SUSQUEHANNA - UNIT 2

The following three questions are addressed for each of the proposed changes:

FIGURE 3.2.3-1b

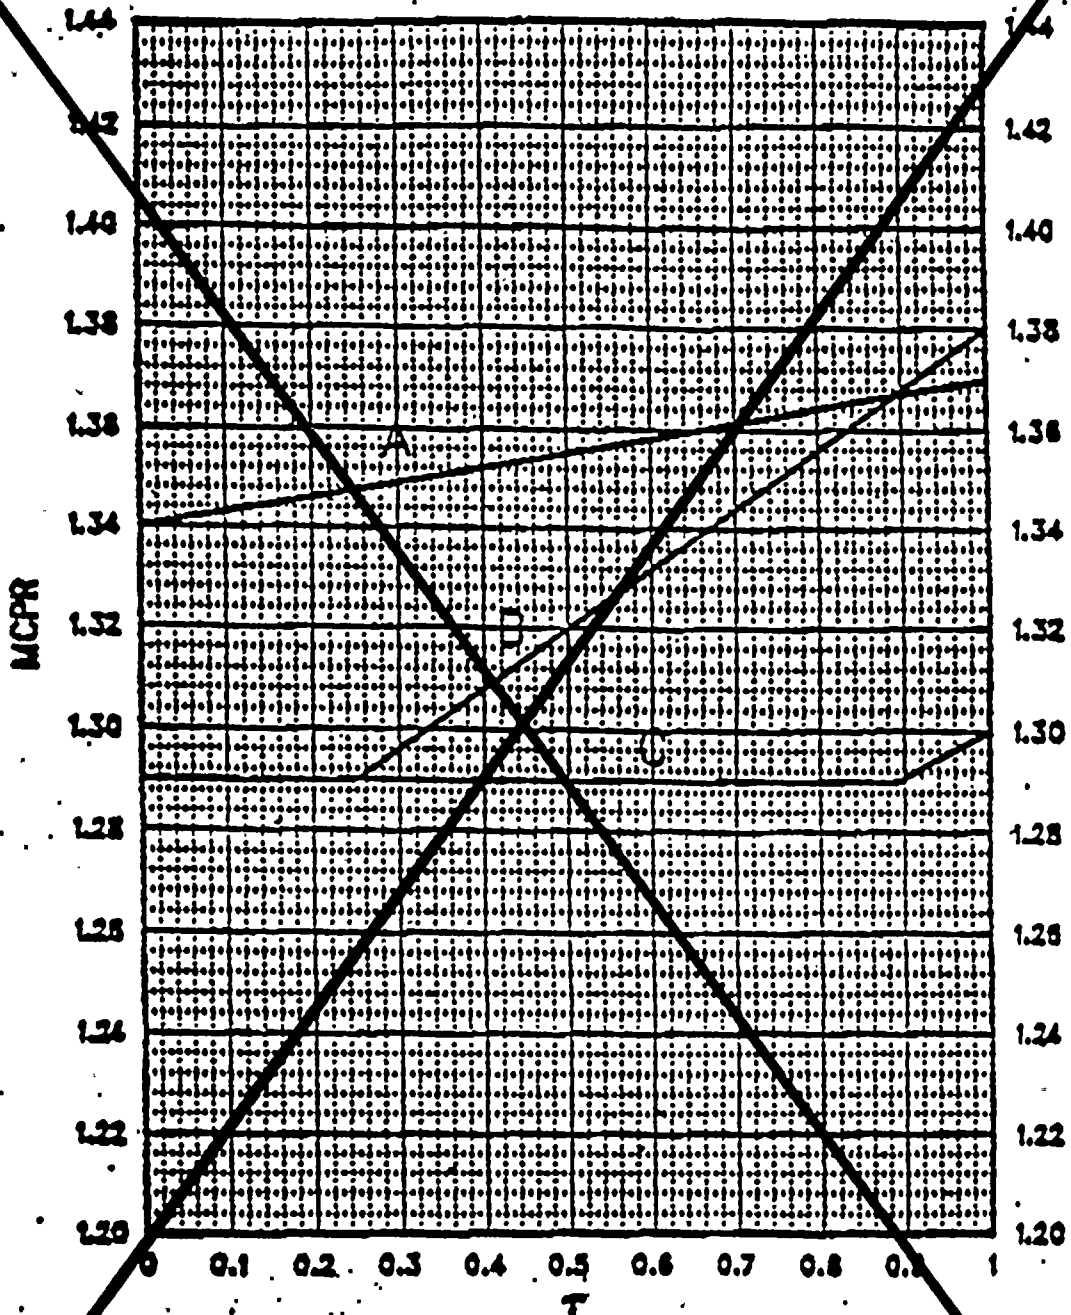
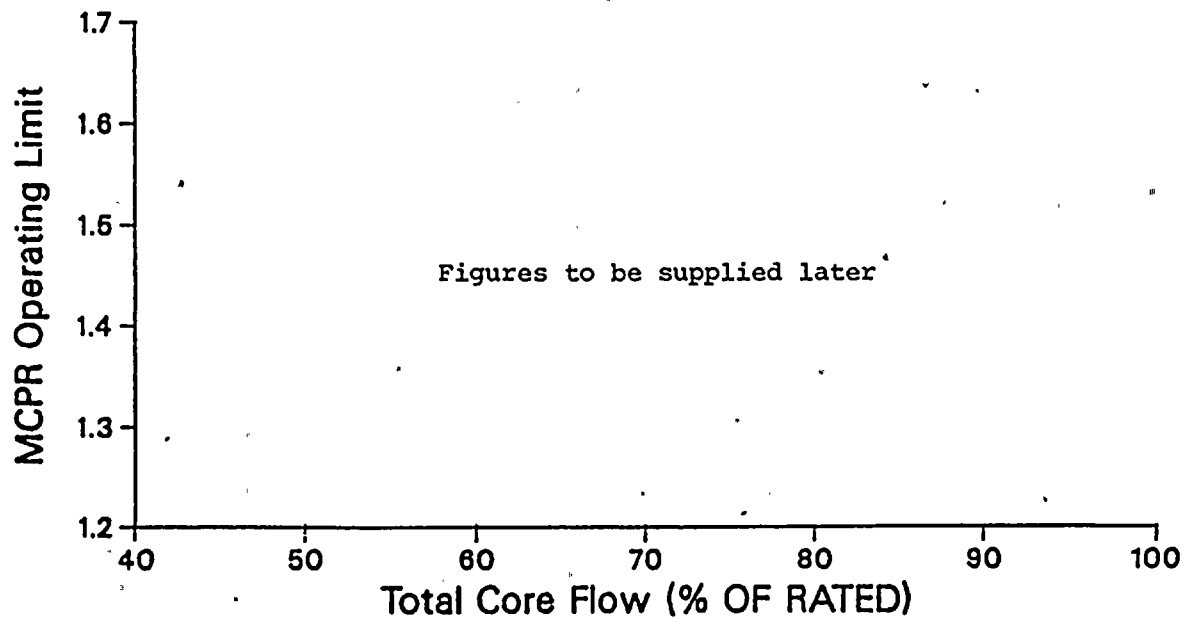
REPLACE
WITH FIGURE
3.2.3-1

When the less operationally limiting Rod Block Monitoring trip setpoint (.66W + 42% from Table 3.3.6-2) is used, the more limiting MCPR curve Figure 3.2.3-1b is applicable due to a larger delta MCPR from the ~~limiting~~ Rod Withdrawal Error (RWE) transient. Figure 3.2.3-1a is applicable when the Rod Block Monitor trip setpoint (.66W + 40% from Table 3.3.6-2) is used.

FIGURE 3.2.3-2

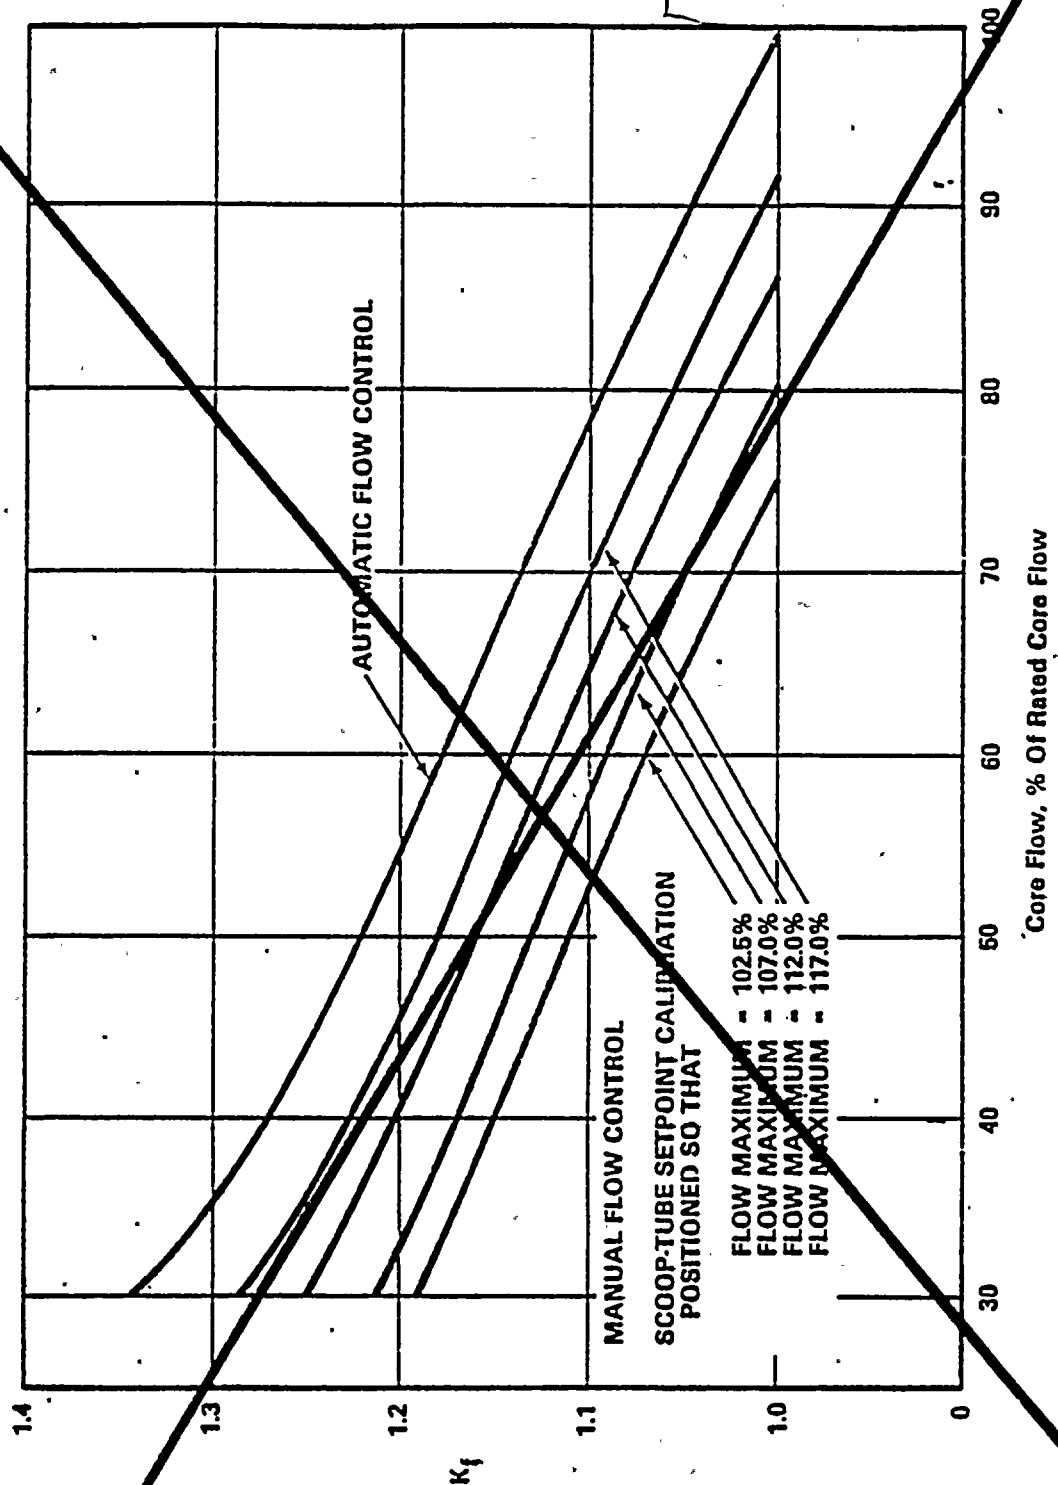
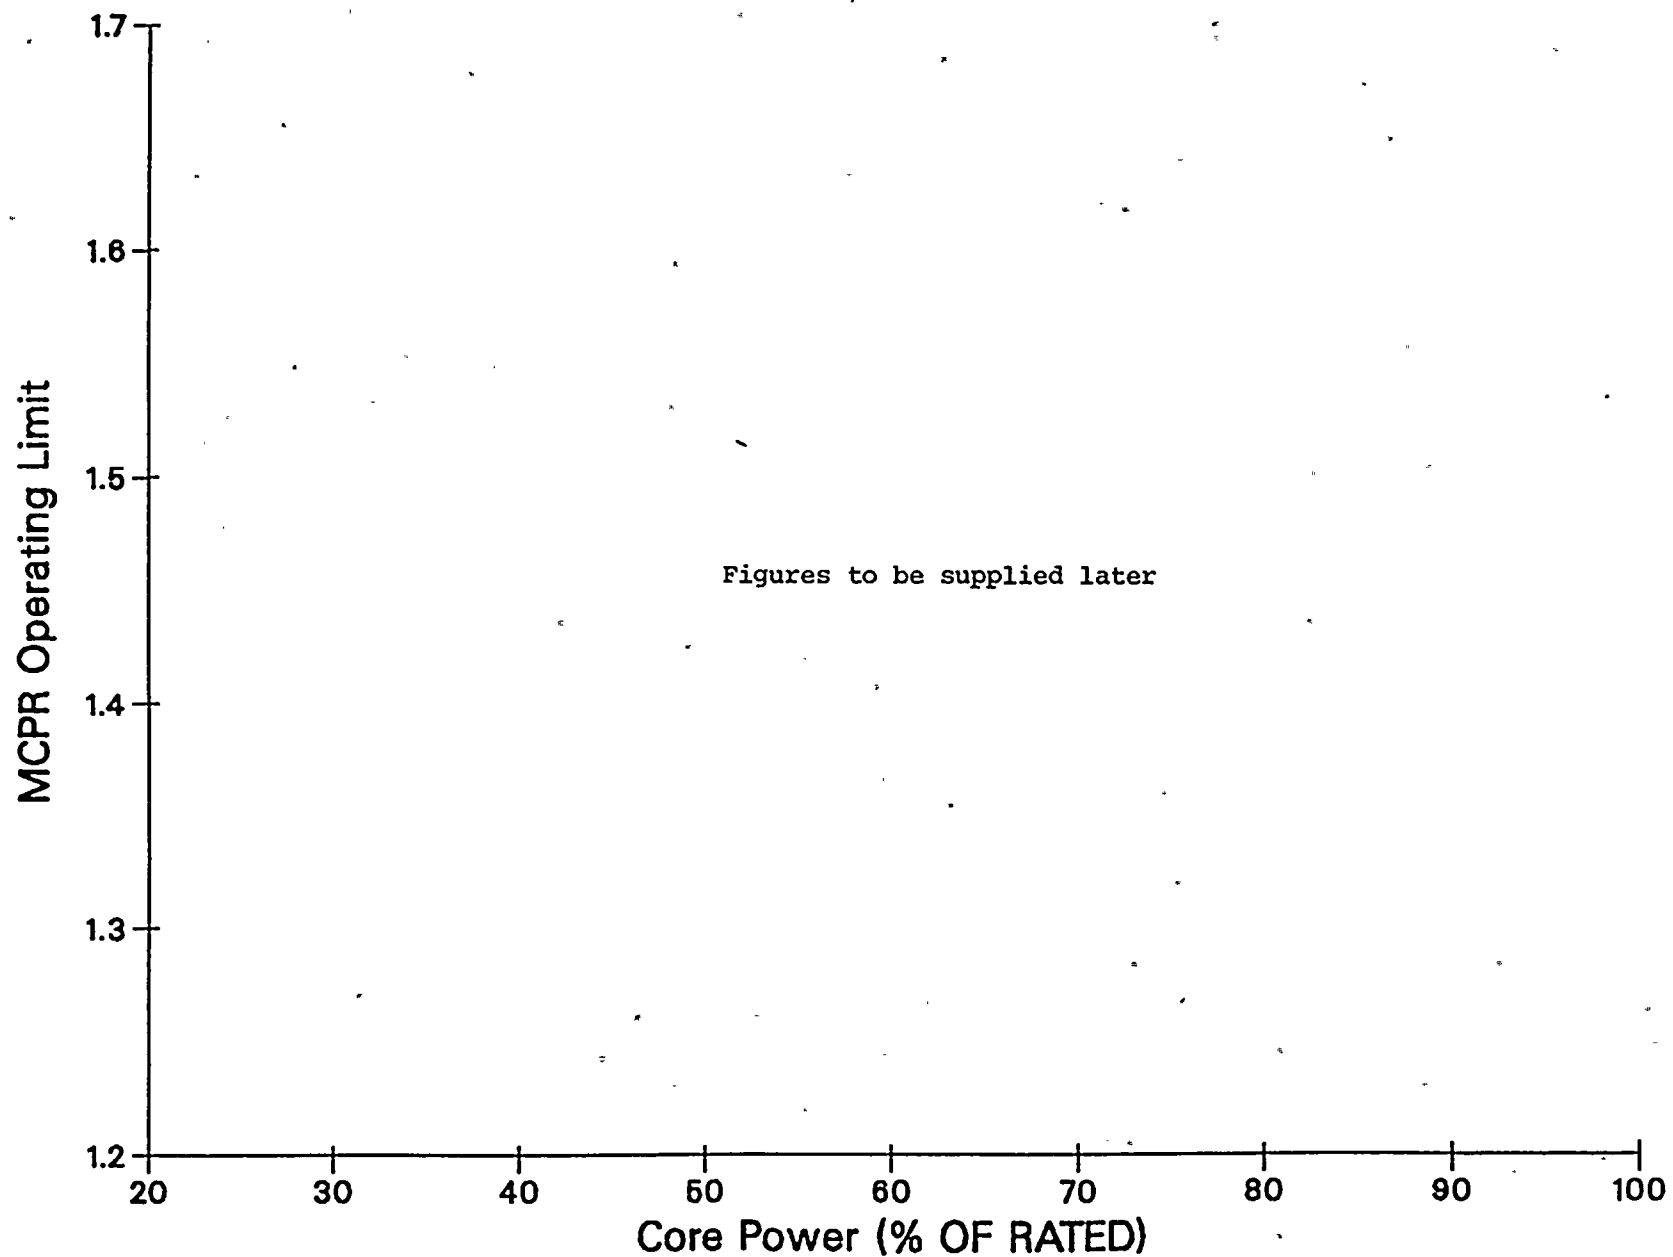
DELETE

REPLACE w/
FIGURE 3.2.3-2

Figure 3.2.3-2 defines the power dependent MCPR operating limit which assures that the Safety limit MCPR will not be violated in the event of a feedwater controller failure initiated from a reduced power condition.

LINEAR HEAT GENERATION RATE (LHGR) LIMIT
VERSUS AVERAGE PLANAR EXPOSURE
EXXON 9X9 FUEL
FIGURE 3.2.4.2-1

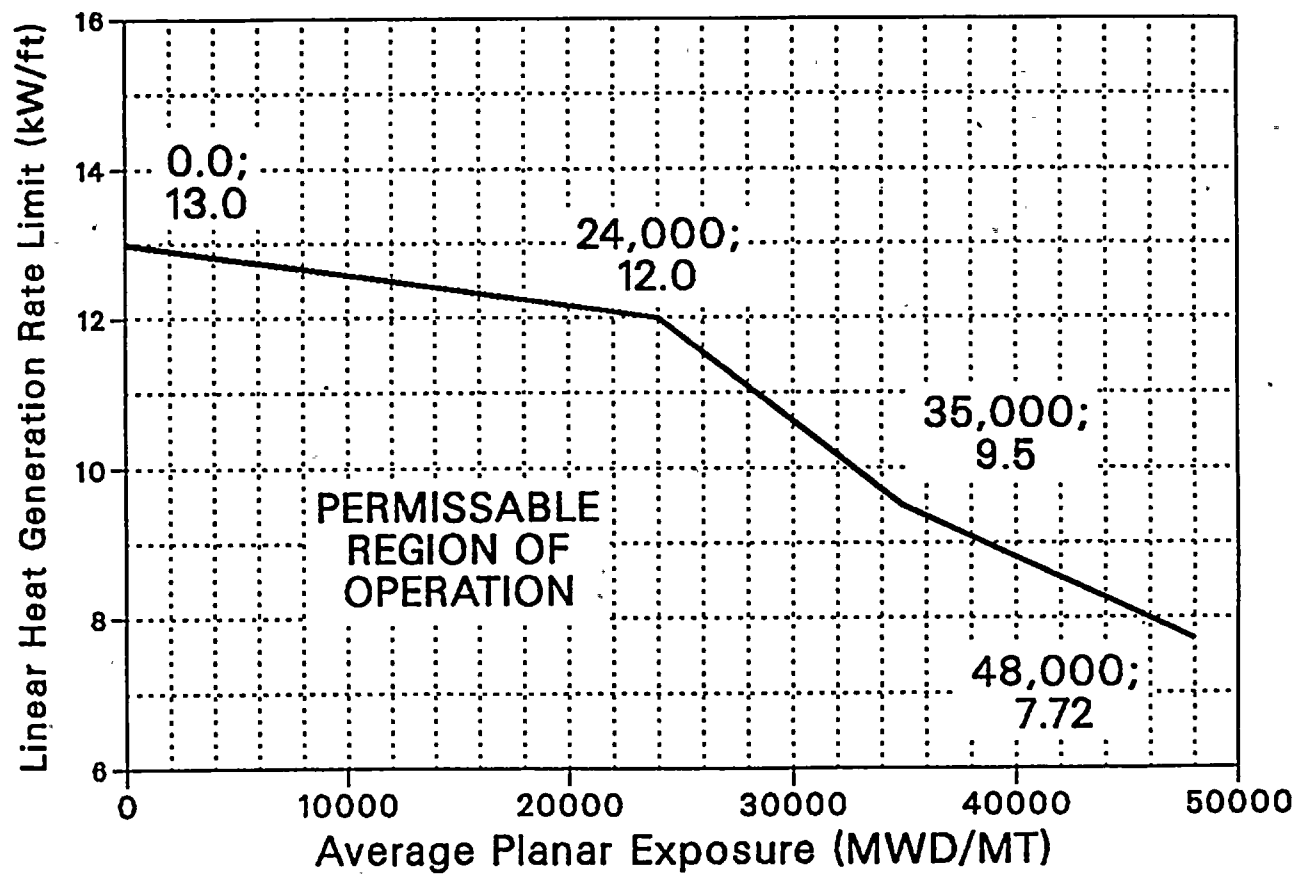
This specification has been changed to provide appropriate limits for ENC fuel. The GE limit of 13.4 kw/ft has not changed.

- I. No. New specification 3/4.2.4.2 and Figure 3.2.4.2-1 reflect appropriate LHGR limits for ENC fuel under steady-state conditions. The figure is based on information provided in the fuel mechanical design analysis (XN-NF-85-67, Rev. 1) and assures margin to design limits for the life of the fuel.
- II. No. This change reflects an additional control which has been previously accepted for GE fuel. Addition of this control to ENC fuel will not create the possibility of a new or different accident.
- III. No. This new control has been shown to ensure compliance with all relevant fuel mechanical design criteria and therefore ensures appropriate safety margin.
